IN RE: PETITIONS FOR SPECIAL EXCEPTION AND ZONING VARIANCES - NS Joppa Road, 644' west of center line of Providence Road (414-416 East Joppa Road) - Ninth Election District

* BEFORE THE
* ZONING COMMISSIONER
* OF BALTIMORE COUNTY
* Case No. 89-246-XA

BALTIMORE COUNTY, MARYLAND
SUBJECT: COUNTY REVIEW GROUP COMMENT
FROM: OFFICE OF PLANNING AND ZONING DATE: 1/5/89

PROJECT NAME: The Traffic Group XXXXXX PLAN
PROJECT NUMBER: 1X-570

No. Description	Date
Revisions	
Proj. No.	88065
Date	21 OCT 88
Scale	AS NOTED
Last Rev.	30 DEC 88
Title	CRG PLAN/PLAT TO ACCOMPANY PETITION FOR SPECIAL EXCEPTION FOR CLASS B BUILDING
Sheet	1

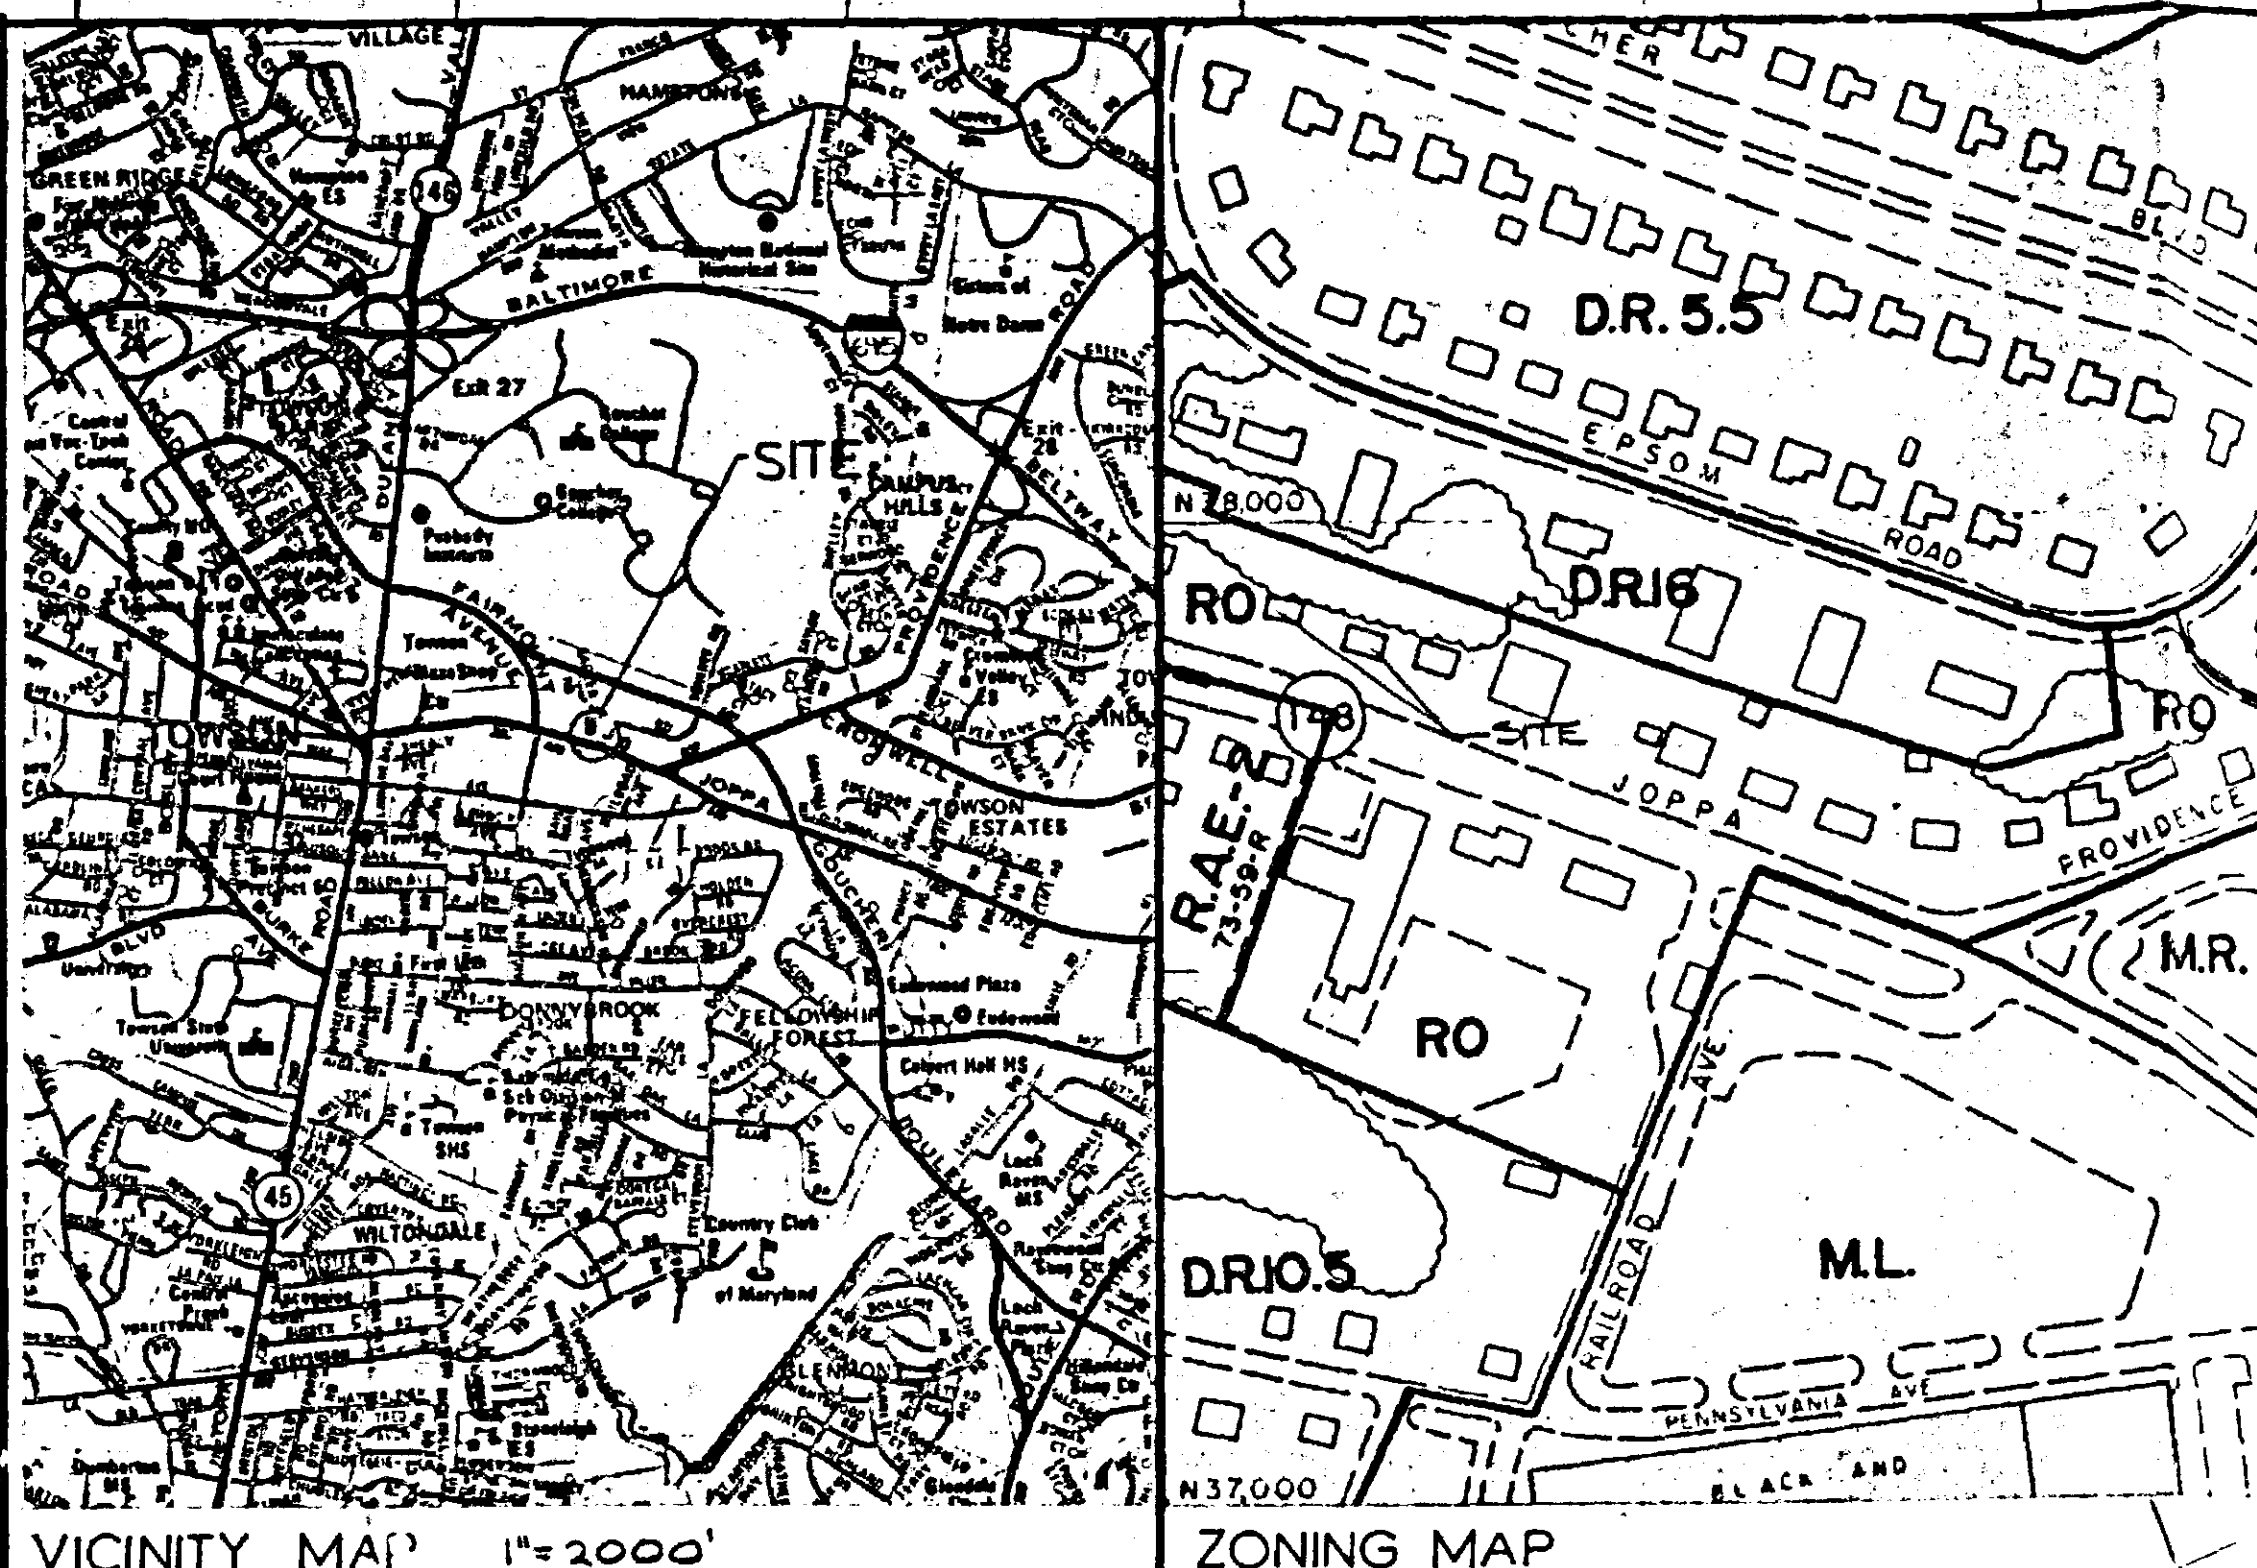
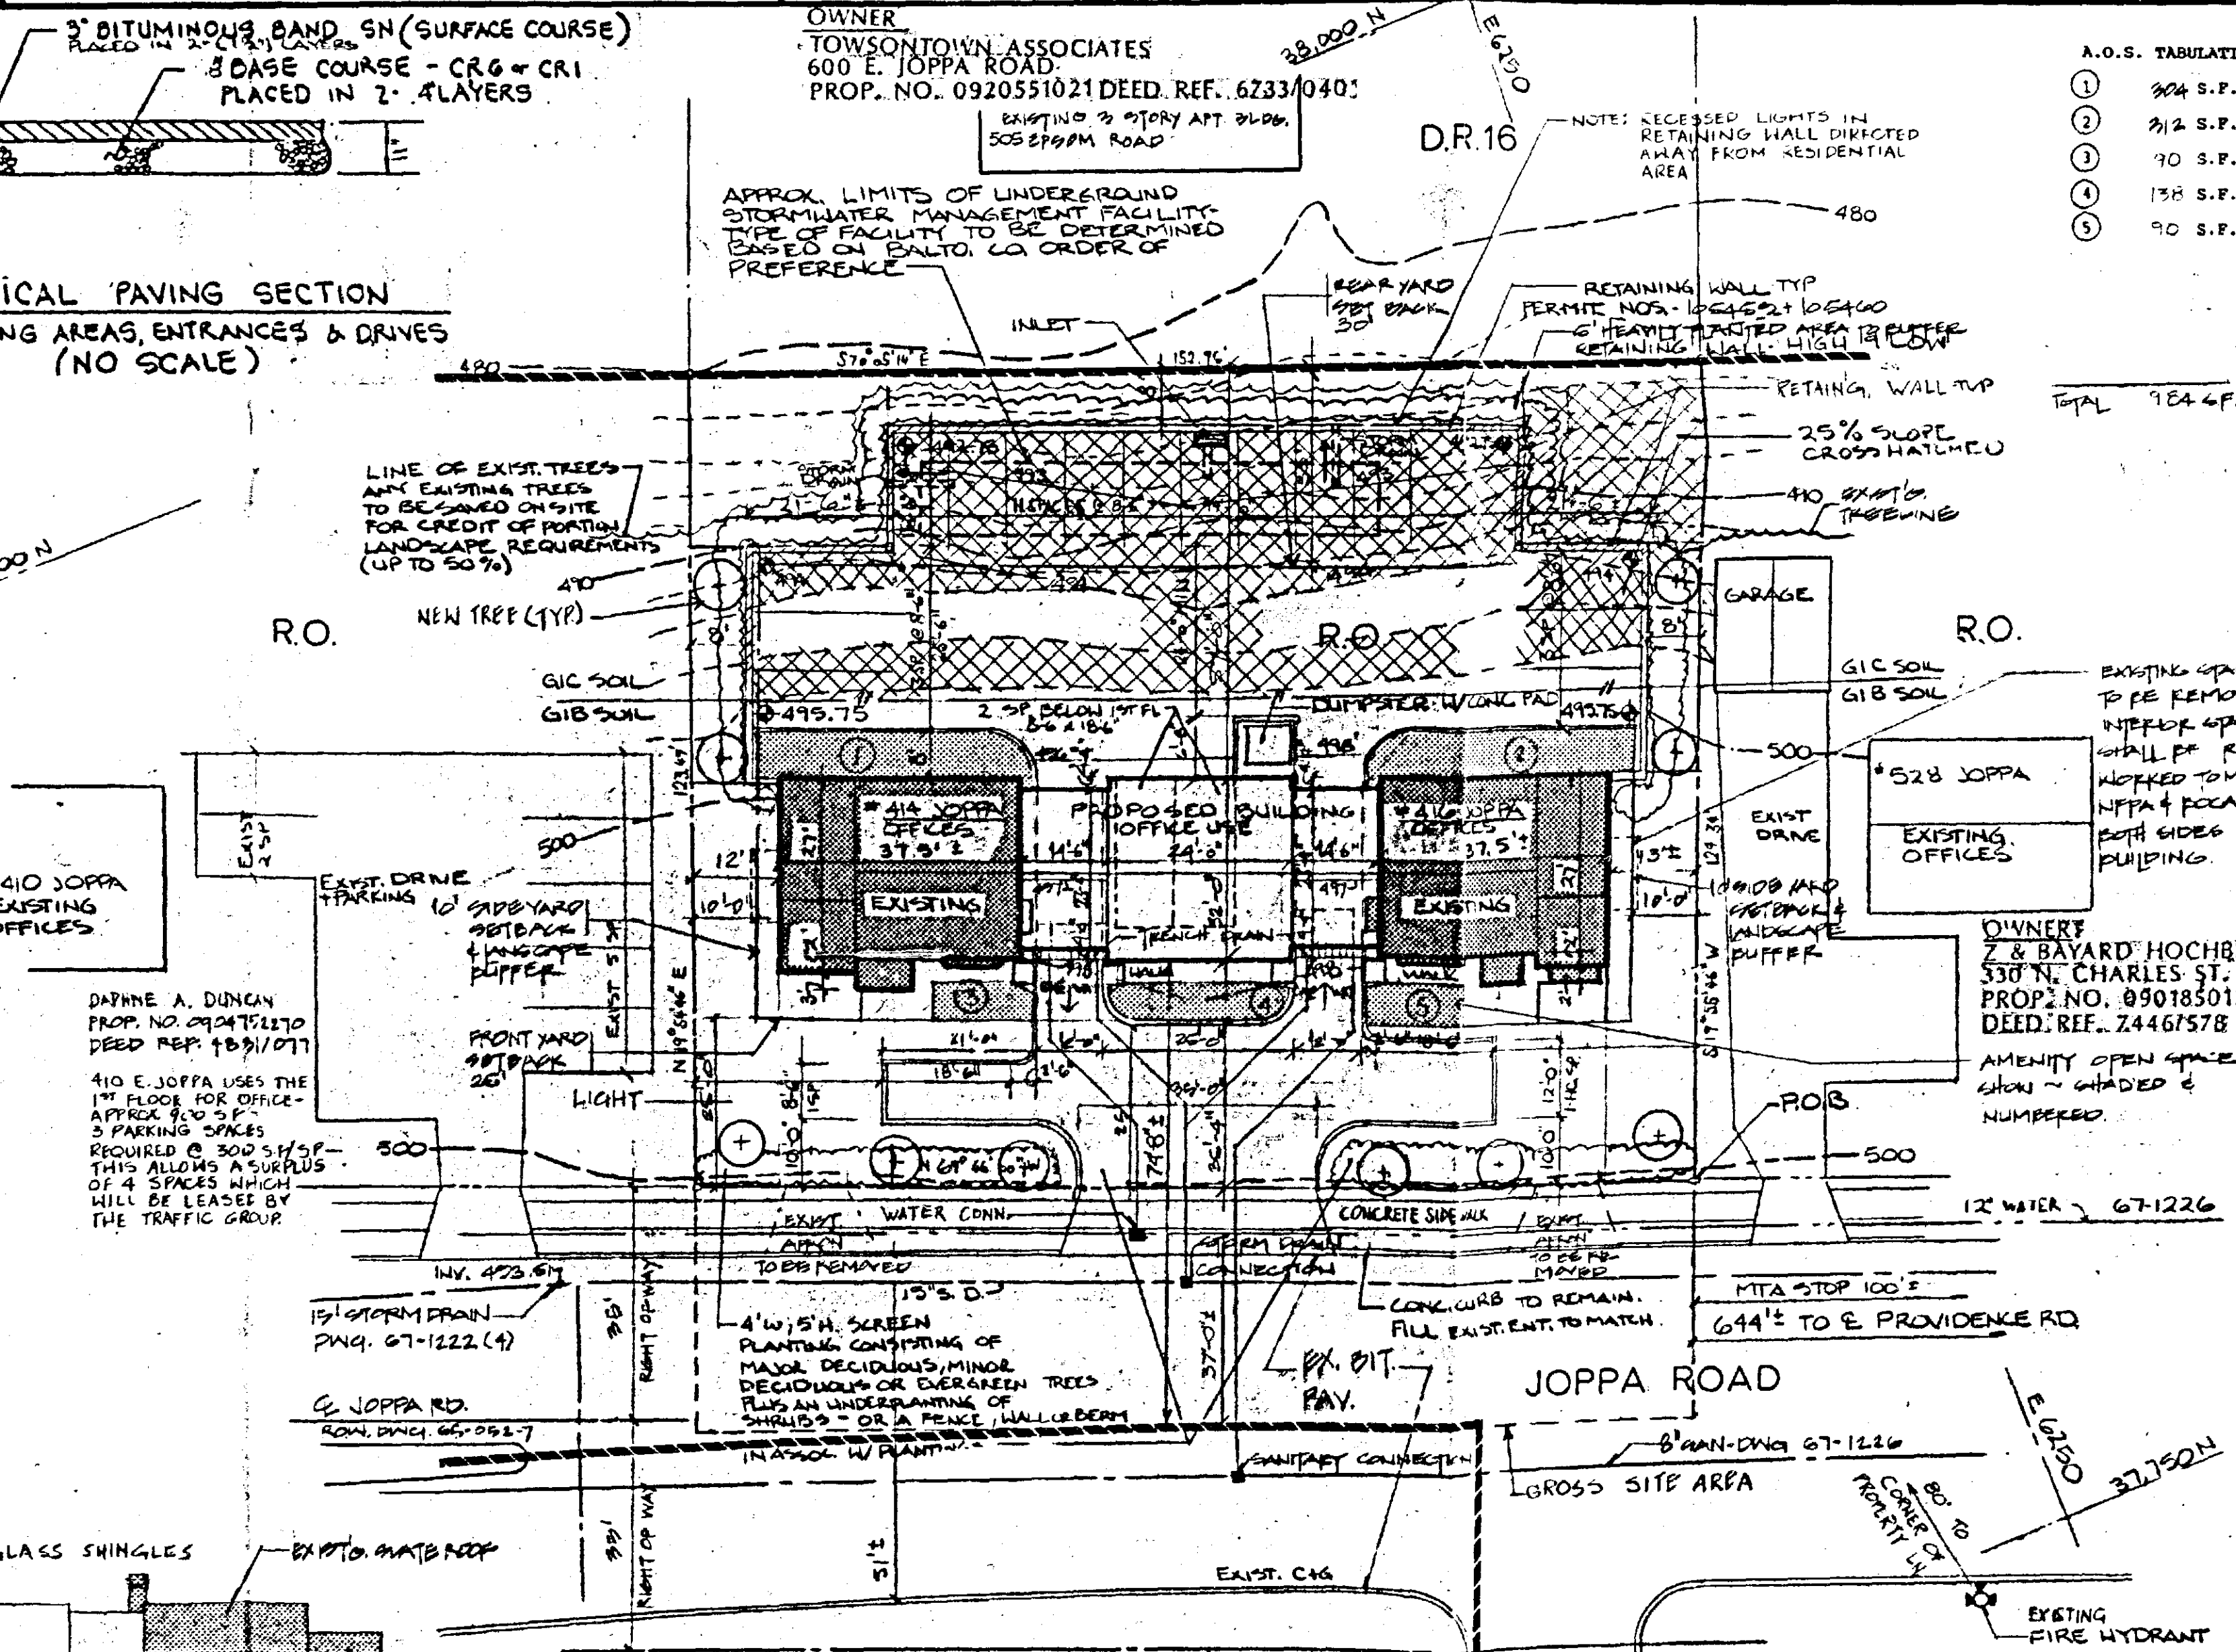
The Office of Planning and Zoning has reviewed revised CRG plans elevation drawings and cross sections dated December 30, 1988 and has the following comments:

- o adequate rear yard buffer of 20 feet from parking adjacent to residential uses is not being provided. The applicant is proposing an 8 foot buffer.

- o the 10 foot side yard buffers although adequate for the buildings, is not maintained for the parking area, only 3 foot is proposed.
 - o it is unclear whether the floor area ratio proposed is .27 or .36 - note 25 indicates the former while note 35 indicates the latter.
